**ADDENDUM NO. 1**

Project: **STEPHENSON SCHOOL BUILDING & PARKING IMPROVEMENTS**

Owner: **City of Dripping Springs, Texas**

Date: **July 8, 2025**

2 ADA/Unisex RR 1 - South  
3/8" = 1'-0"

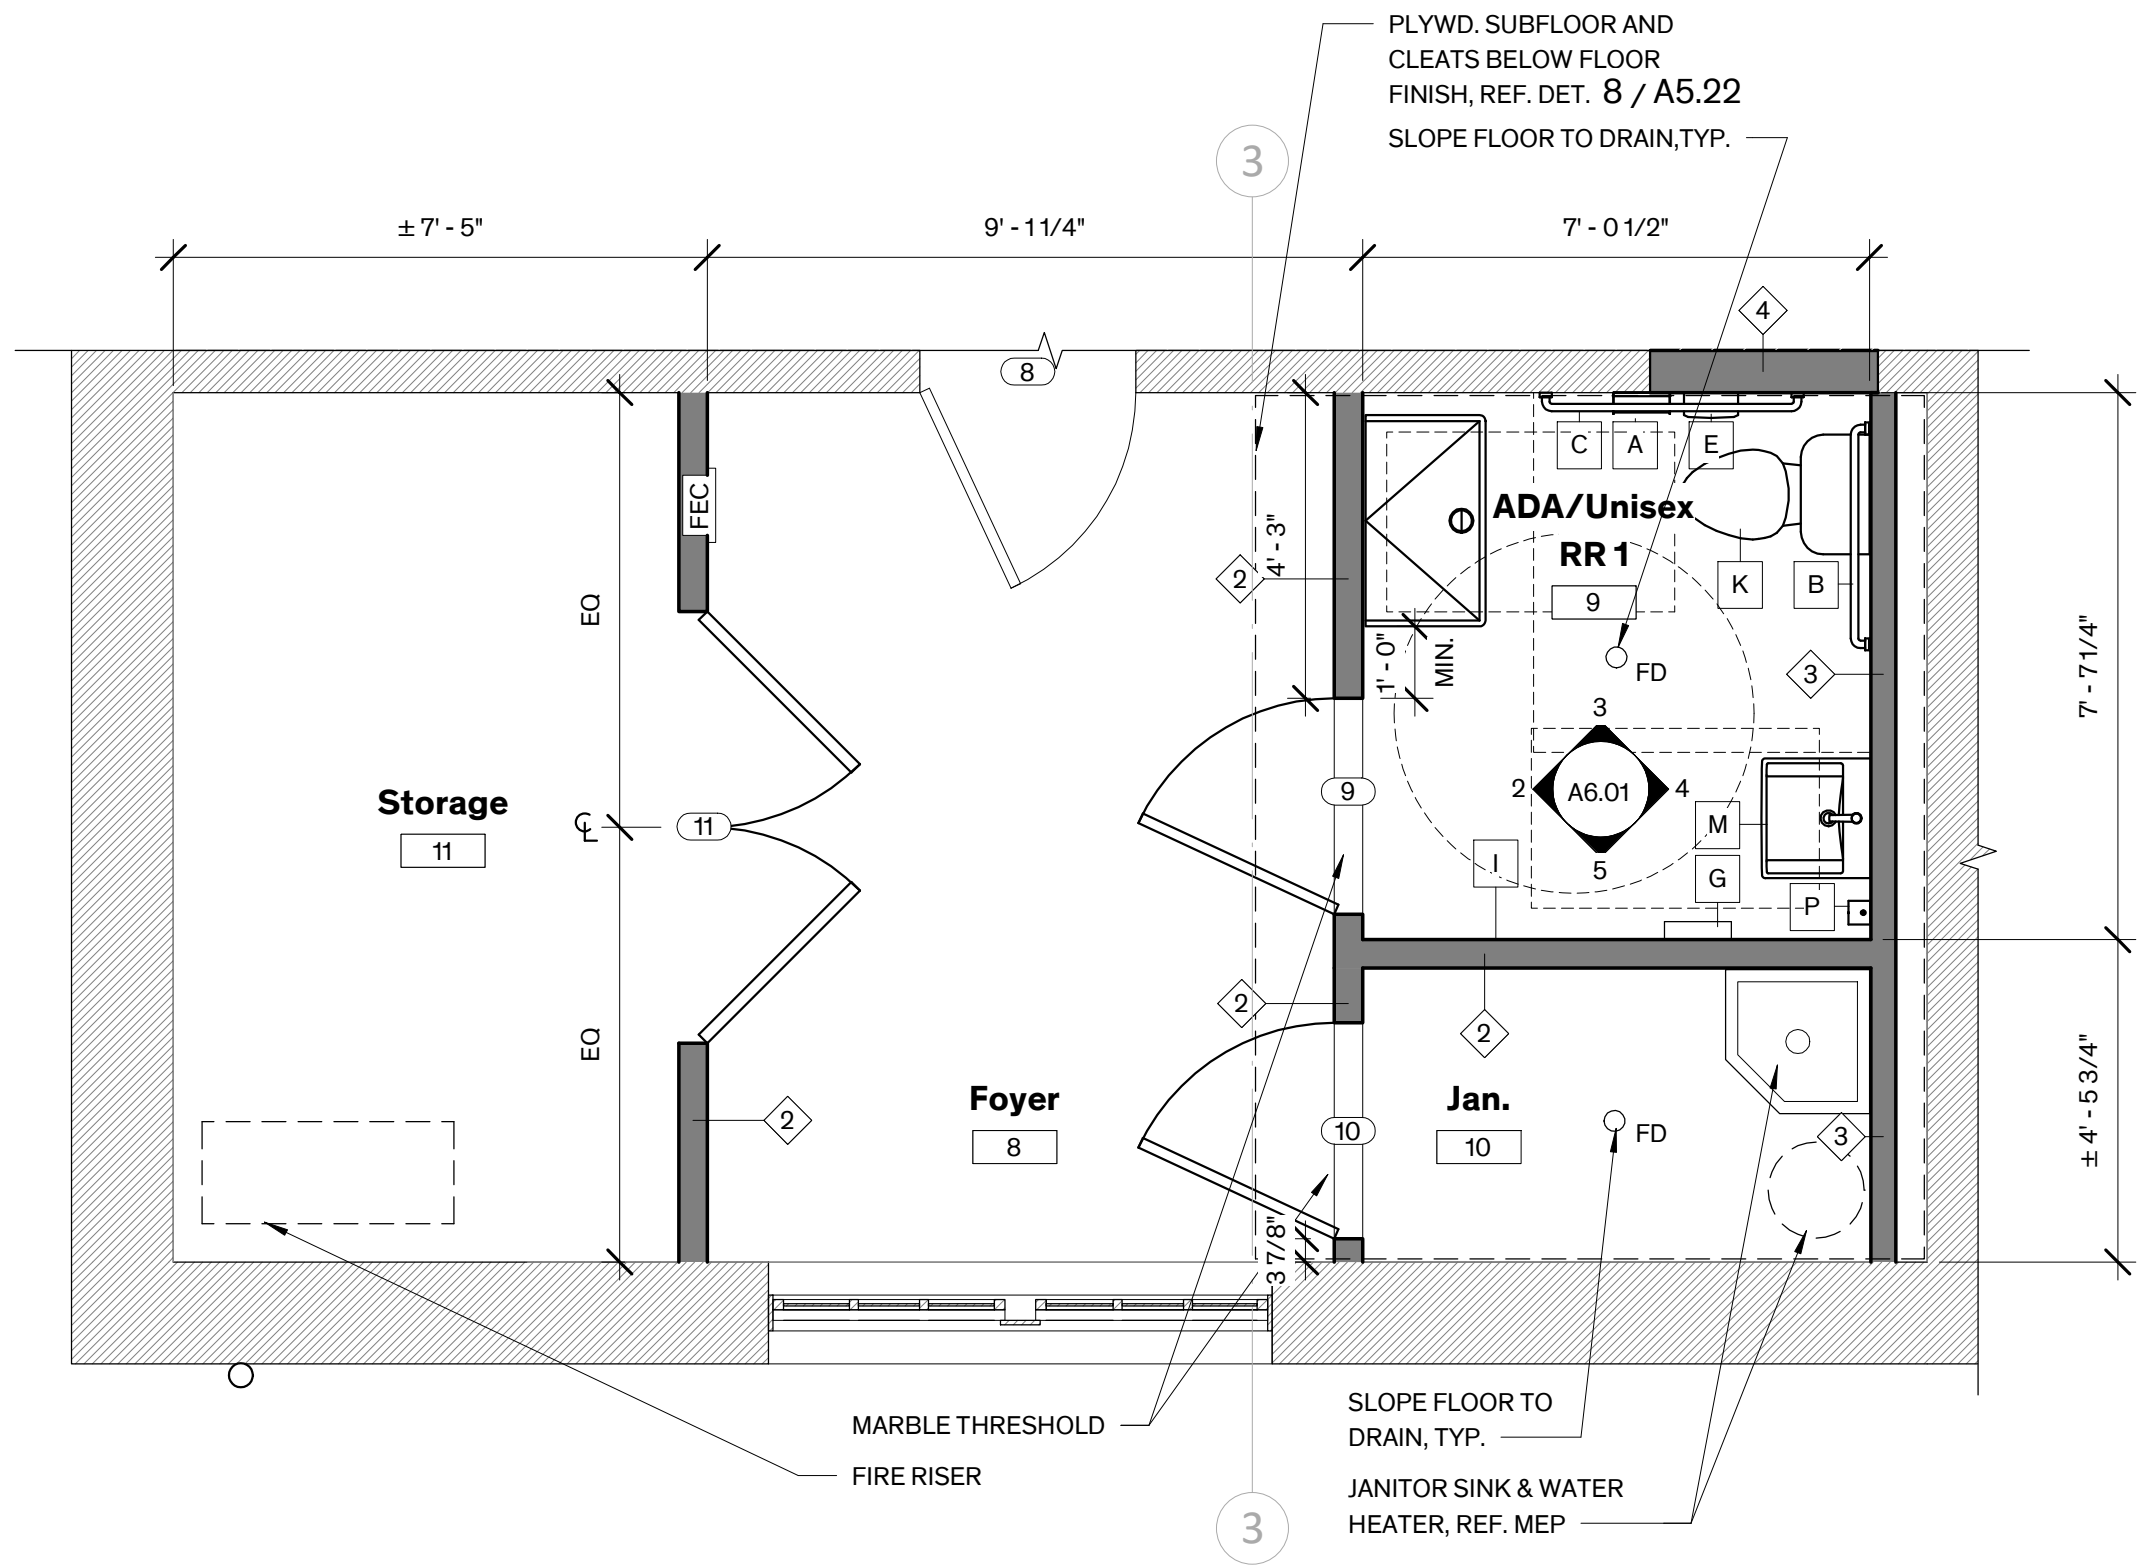
UPDATE – Provide TAS handrail mounting height range in ADA legend.

Addition Restrooms Enlarged

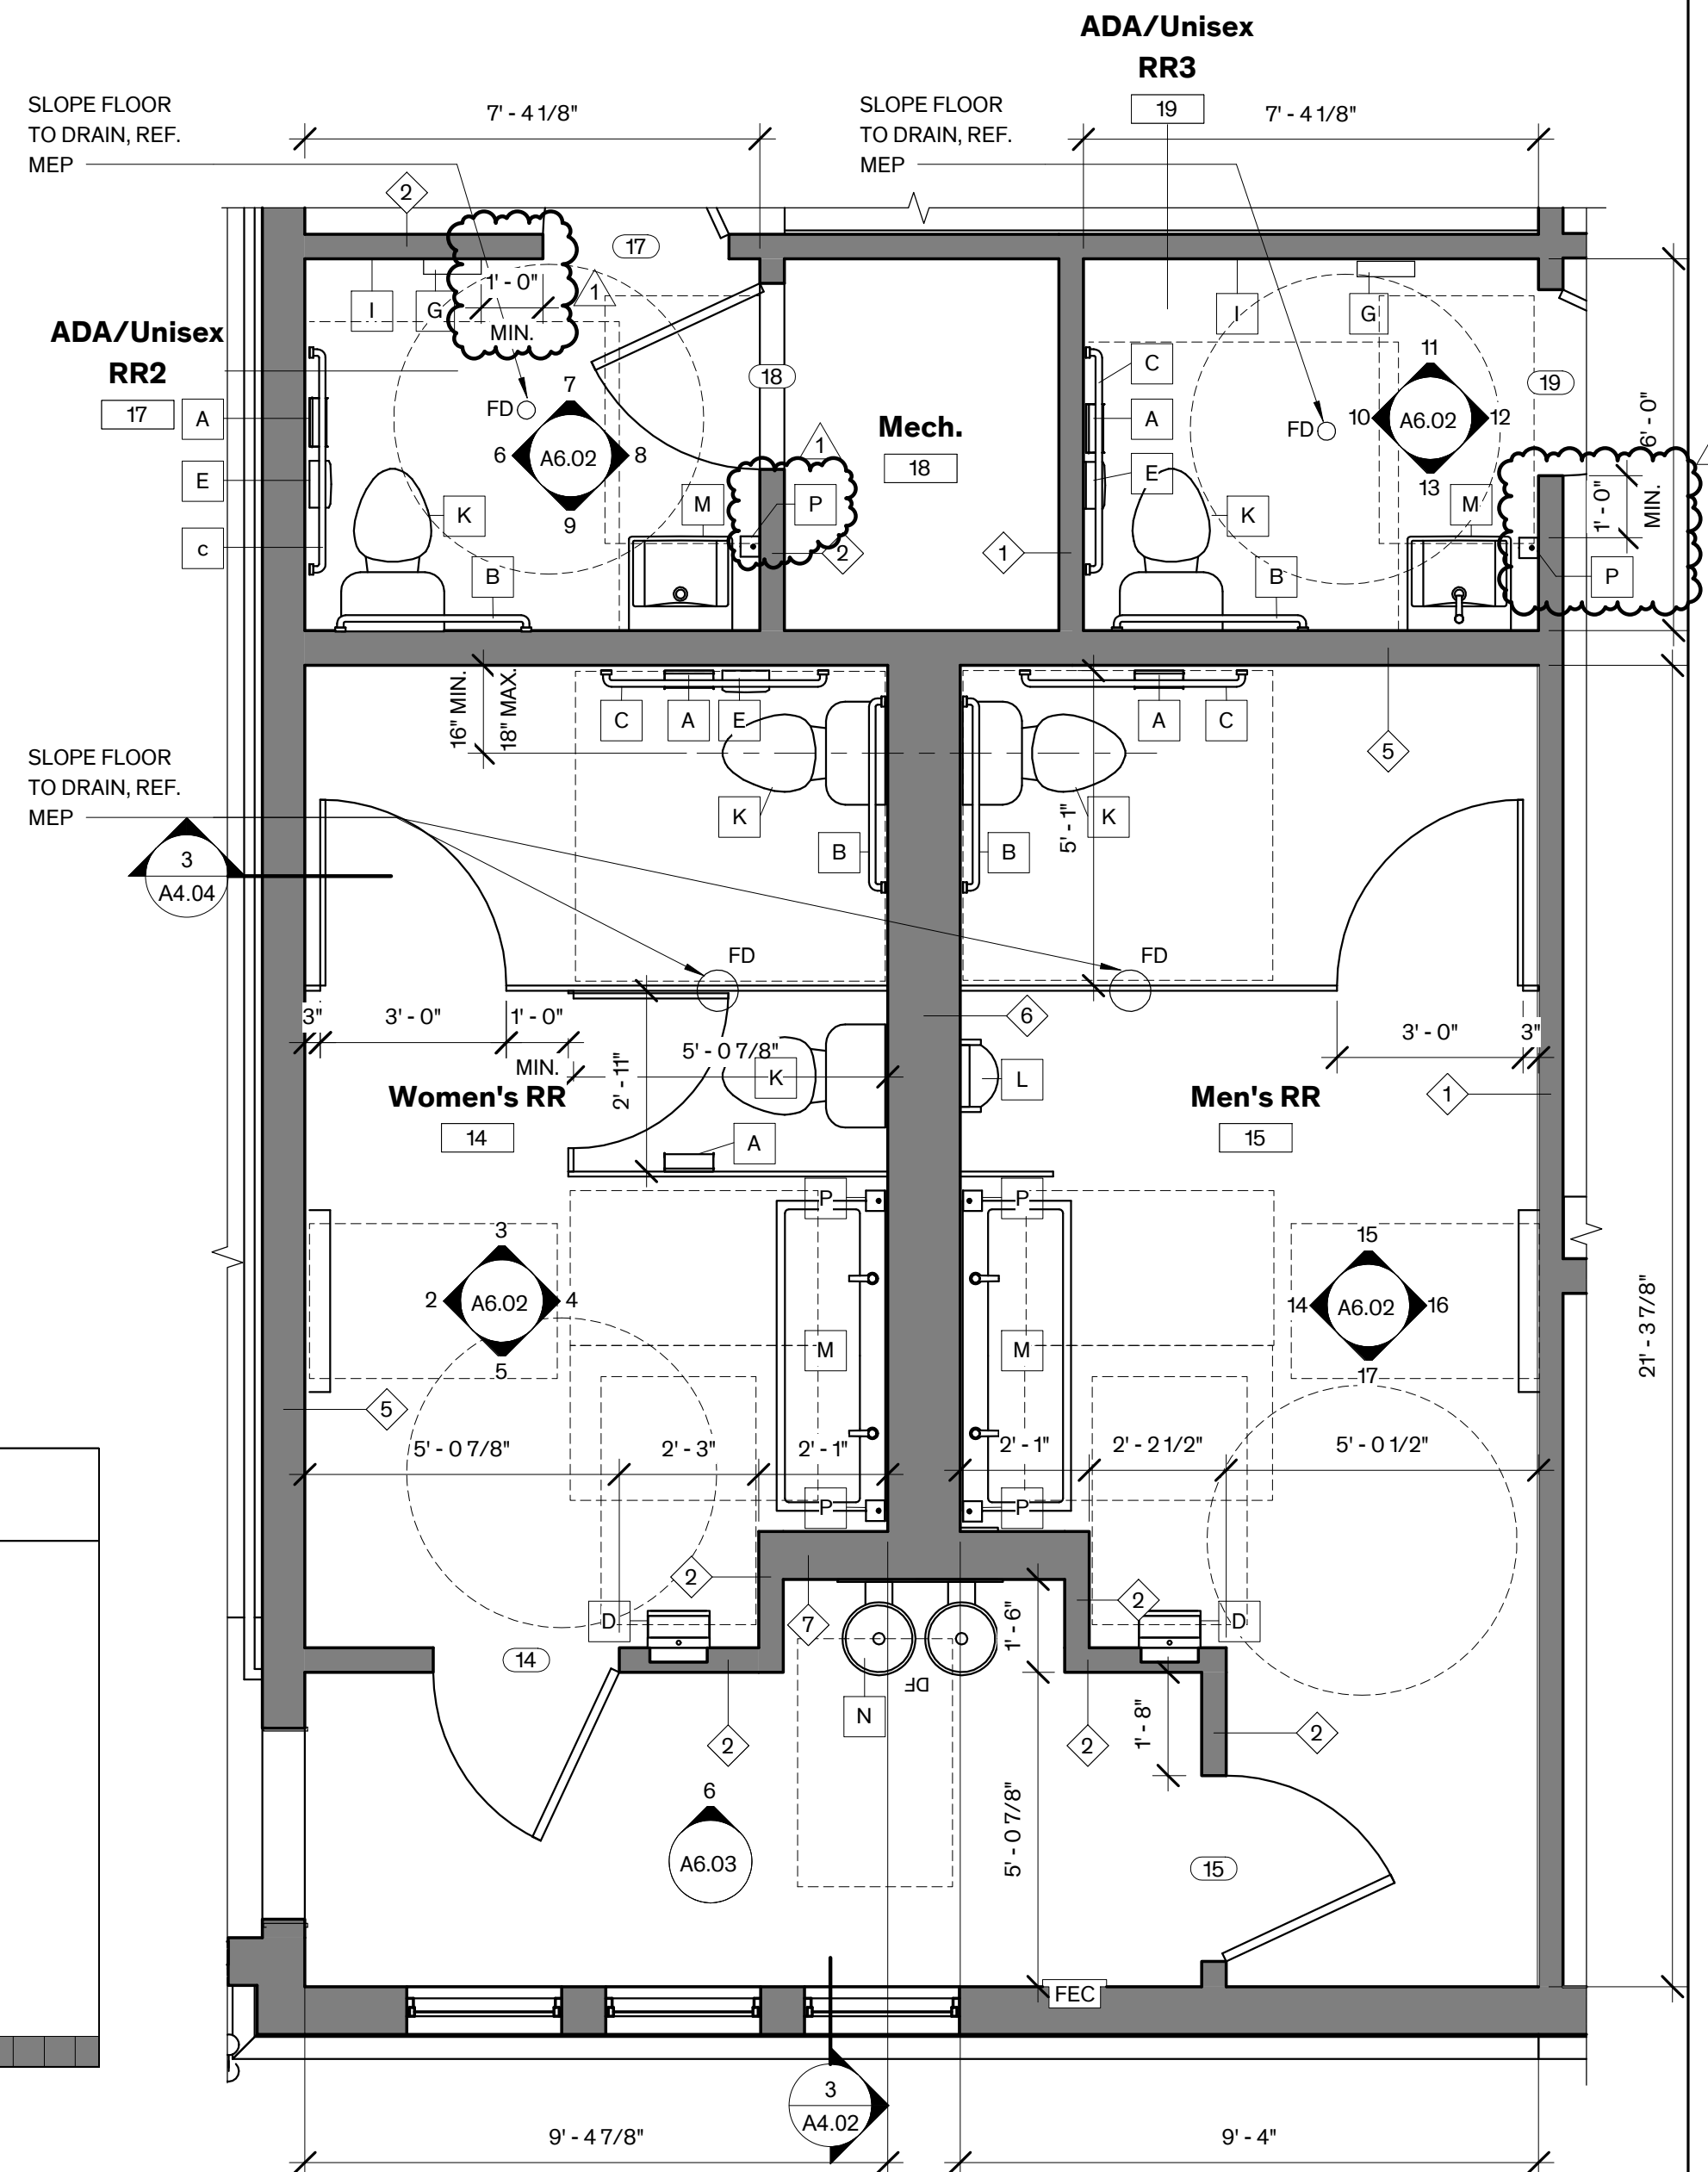
UPDATE – Relocate soap dispenser in accessible restrooms 17 & 19 for TAS compliance. Provide additional dimensions for TAS compliance at room 19.

**1 Green Room Enlarged Plan**  
3/8" = 1'-0"

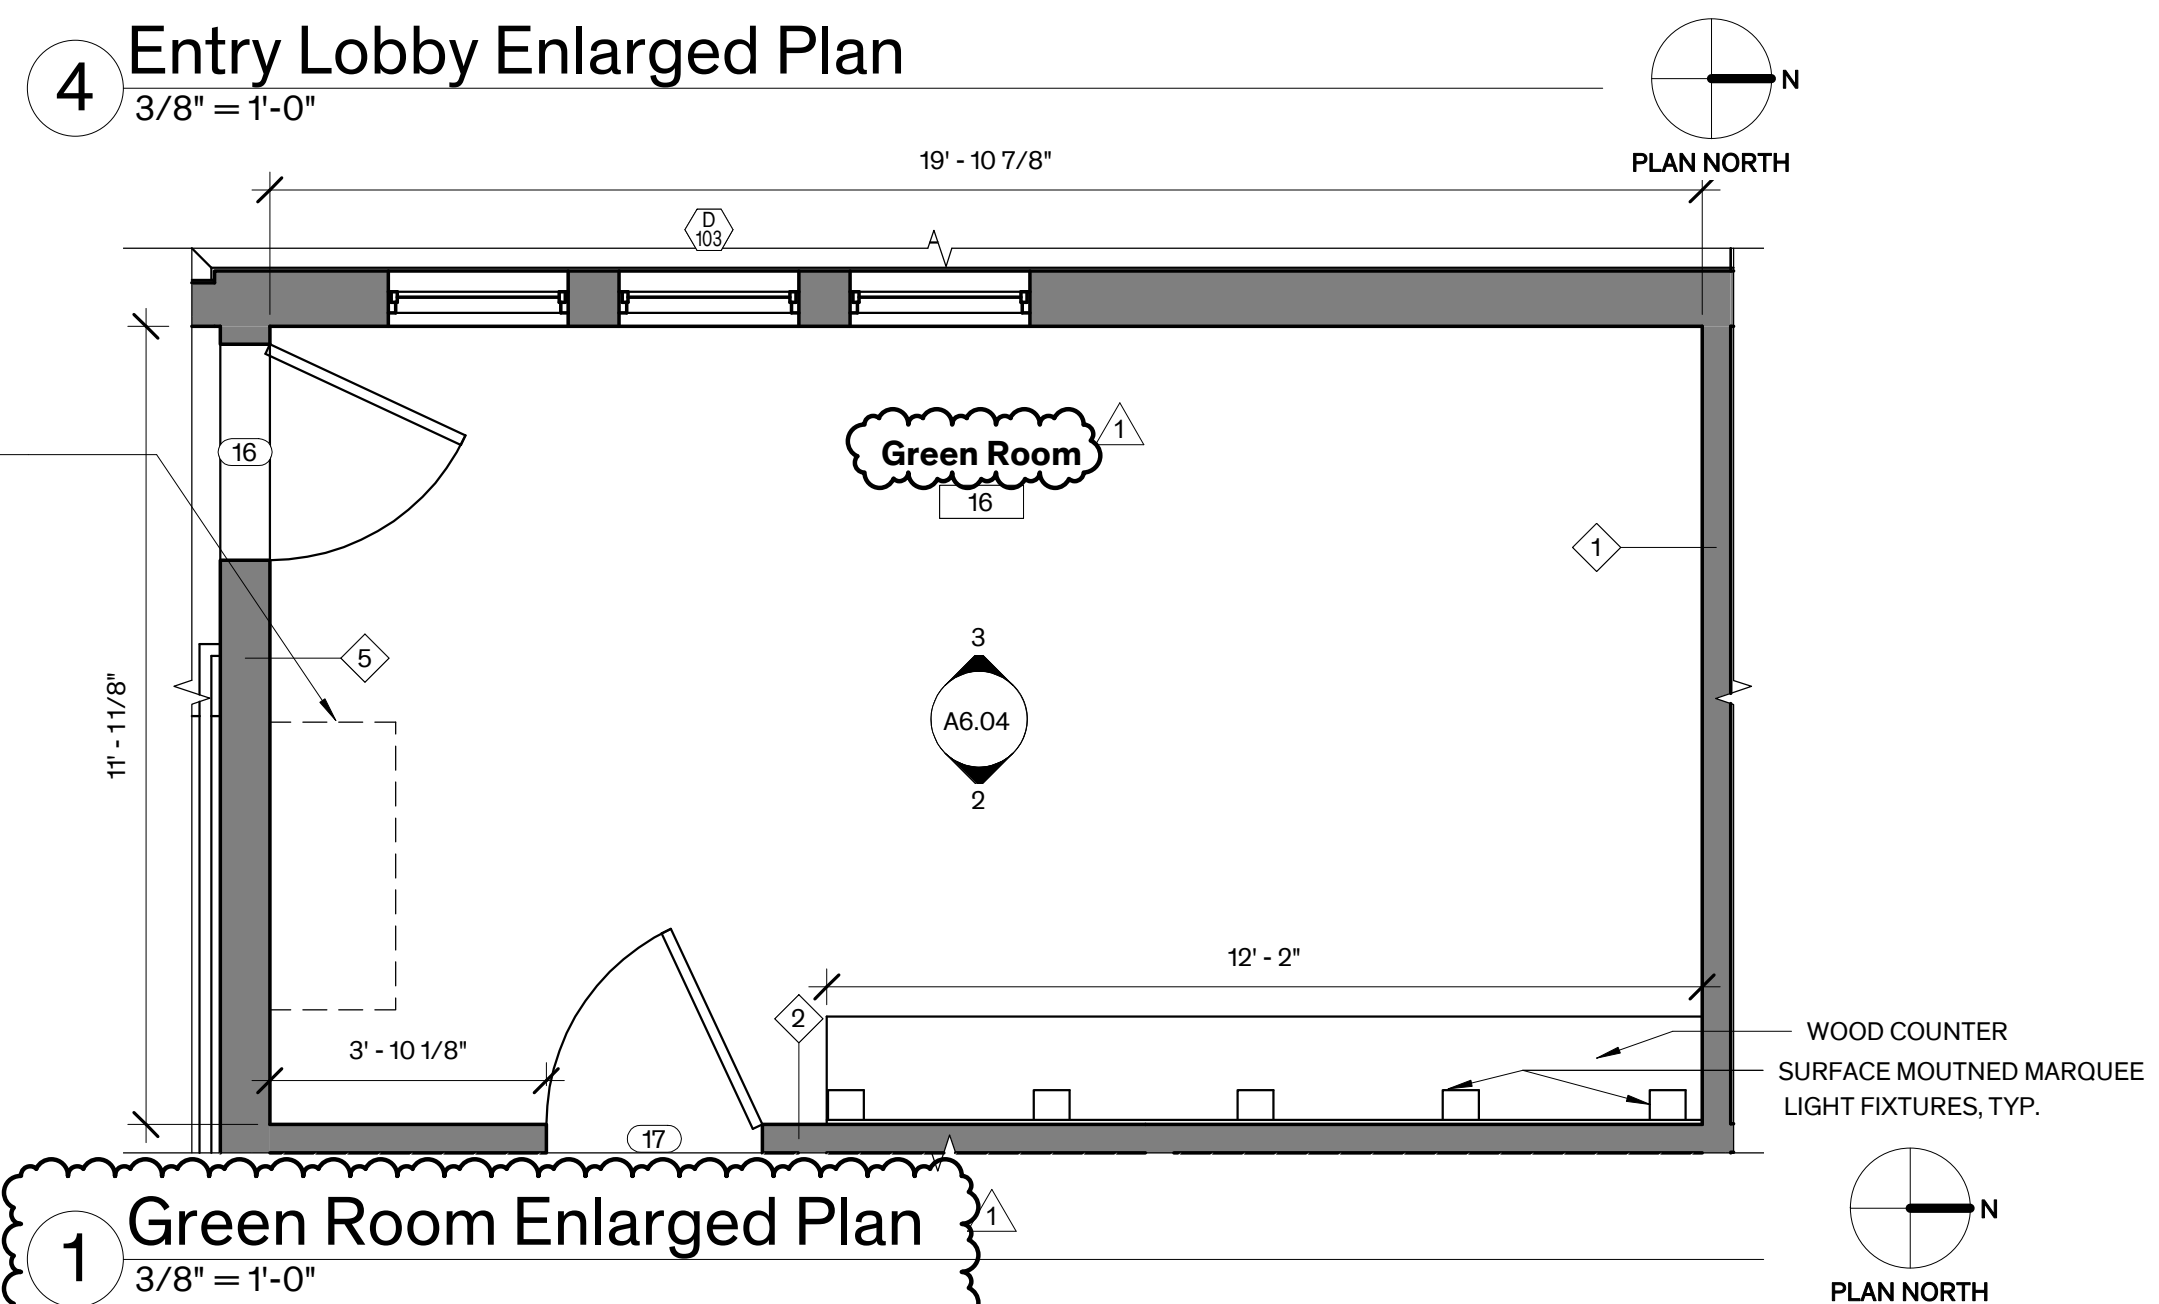
UPDATE – Update room name for Green Room – Room 16.

3 Green Room Counter

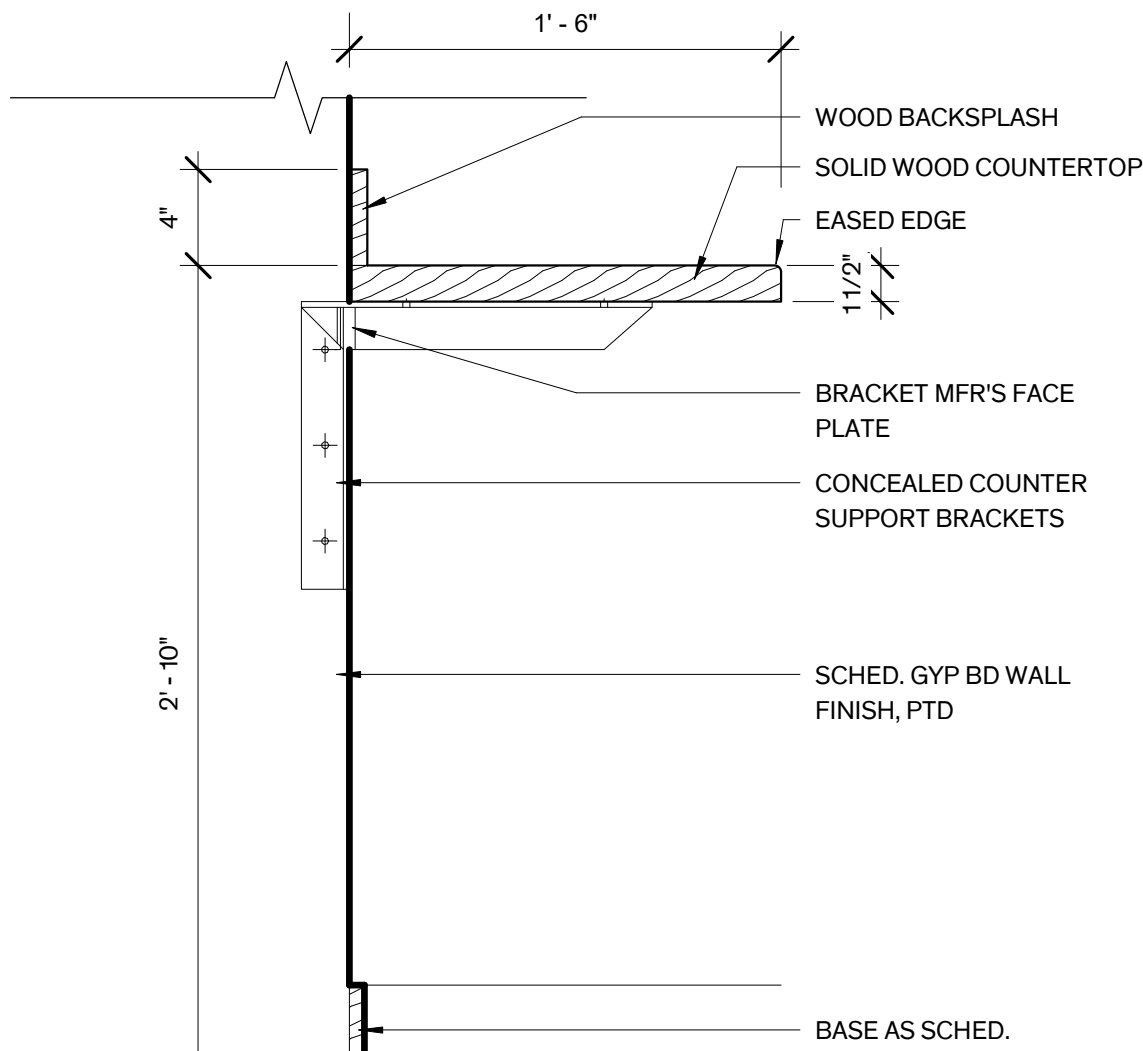
UPDATE – Update room name for Green Room – Room 16.
